APPLICATION NO.	FILING DATE	FIRST NAMED INVENTOR	ATTORNEY DOCKET NO.	CONFIRMATION NO.
10/672,316	09/26/2003	Hari Hara Kumar Venkatachalam	K28.12-0001	8394
27367 7590 08/06/2007 WESTMAN CHAMPLIN & KELLY, P.A. SUITE 1400			EXAMINER	
			DINH, DUC Q	
900 SECOND AVENUE SOUTH MINNEAPOLIS, MN 55402-3319			ART UNIT	PAPER NUMBER
	,		2629	•
		* .		
			MAIL DATE	DELIVERY MODE
			08/06/2007	PAPER

DETAILED ACTION

FIG. 26

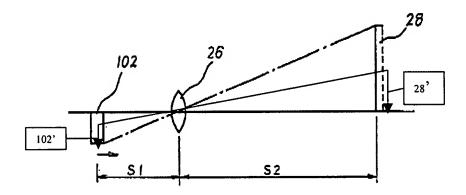
In reference to claim 10, as shown in modified of Fig. 26, given the distance S1 and S2 held constant, the size of the virtual screen 28' is proportional (i.e. is a function) to the size of the display 102' as provided below.

It would have been obvious for one of ordinary skill in the art to recognize (in the modified Fig. 26) that the size of virtual screen (28') is a function of a size of an image-forming panel (102') of the projection unit and the larger size of the display 102 provides larger virtual screen virtual screen 28.
